UNITED STATES PATENT AND TRADEMARK OFFICE

APPLICATION NO.	FILING DATE	FIRST NAMED INVENTOR	ATTORNEY DOCKET NO.	CONFIRMATION NO.
10/616,418	07/09/2003	Craig P. Nadel	NN001USU	1280

Office Action Summary	Application No.	Applicant(s)	
	10/616,418	NADEL, CRAIG P.	
	Examiner	Art Unit	
	Troy Chambers	3641	NW

DETAILED ACTION

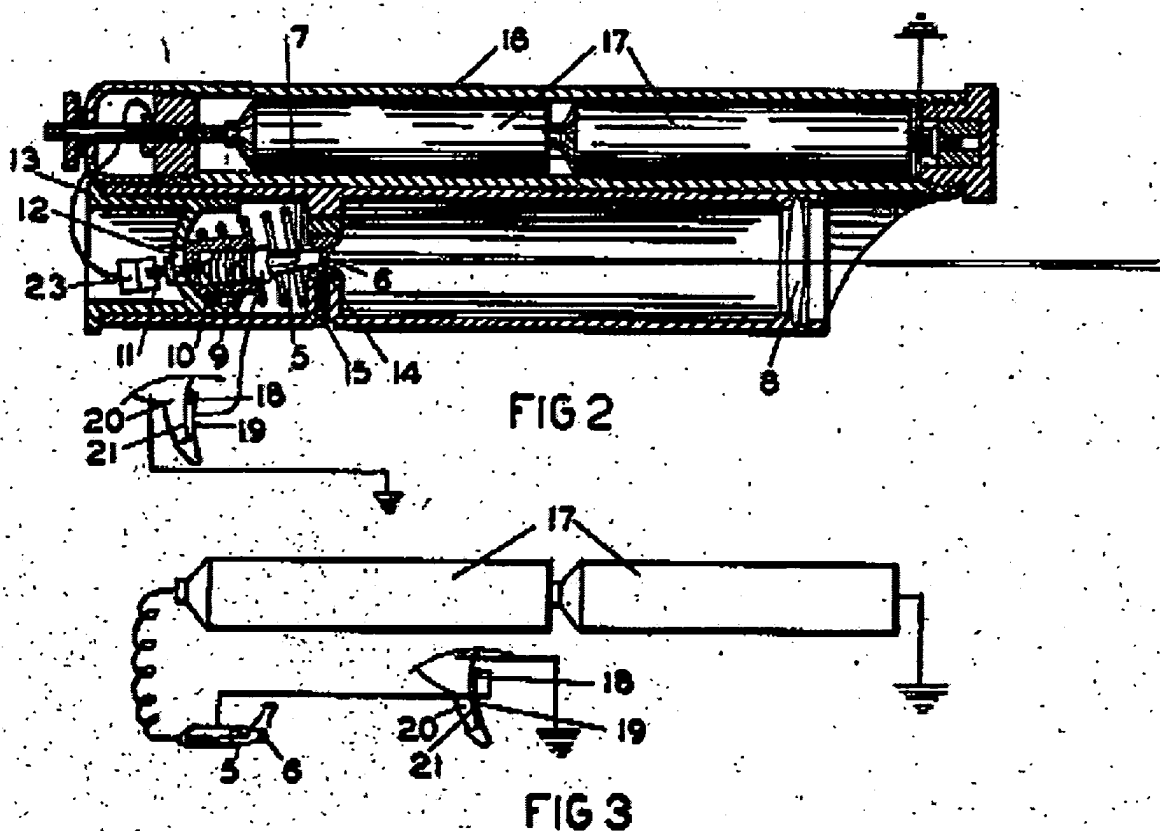
With respect to claim 1, Steer discloses:

A projectile launcher	10
Elongated barrel	30, 40
Forcibly launching means (defined in claims 2 and 3)	20, 70

The pressurized air bellows 20 operates in response to a pulling of the trigger and is thus "hand operated". Although claim 1 recites the term "audiovisual", applicant has elected a species covering only a visual stimulus. Hence, with respect to the

However, Steer does not disclose the means for generating an audiovisual stimulus at about the same time as the launch of at least one projectile. Zinsser discloses such a means including a trigger-actuated (col. 2, ll. 33-43) light bulb 5 connected to batteries 17.

At the time of the invention, one of ordinary skill in the art would have found it obvious to provide the projectile launcher 5 with the trigger-actuated audiovisual stimulus of

Zinsser. The suggestion/motivation for doing so would have been to mark the spot at which the launcher would be directed.

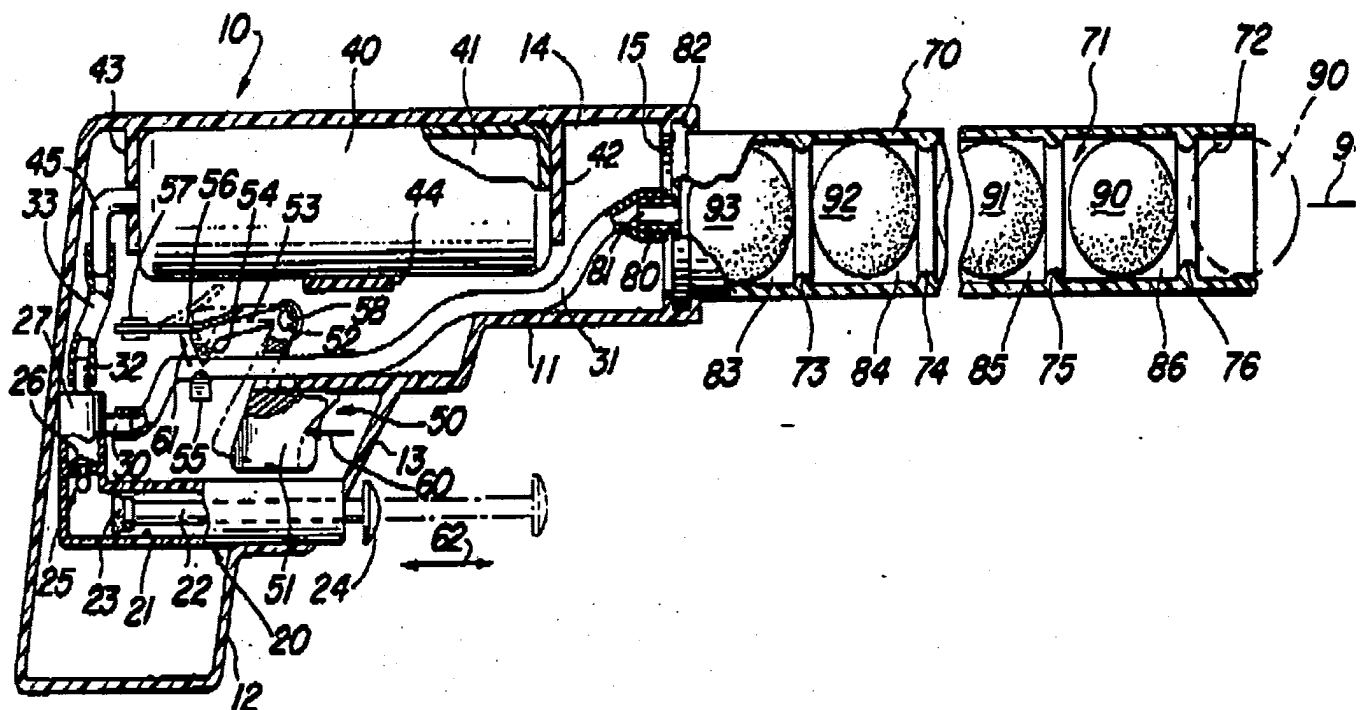
With respect to claim 1, Steer discloses:

A projectile launcher	10
Elongated barrel	70
Forcibly launching means (defined in claims 2 and 3)	20, 25

23. However, Steer does not disclose the means for generating an audiovisual stimulus at about the same time as the launch of at least one projectile. Zinsser discloses such a means including a trigger-actuated (col. 2, ll. 33-43) light bulb 5 connected to batteries 17.

At the time of the invention, one of ordinary skill in the art would have found it obvious to provide the projectile launcher 5 with the trigger-actuated audiovisual stimulus of Zinsser. The suggestion/motivation for doing so would have been to mark the spot at which the launcher would be directed.
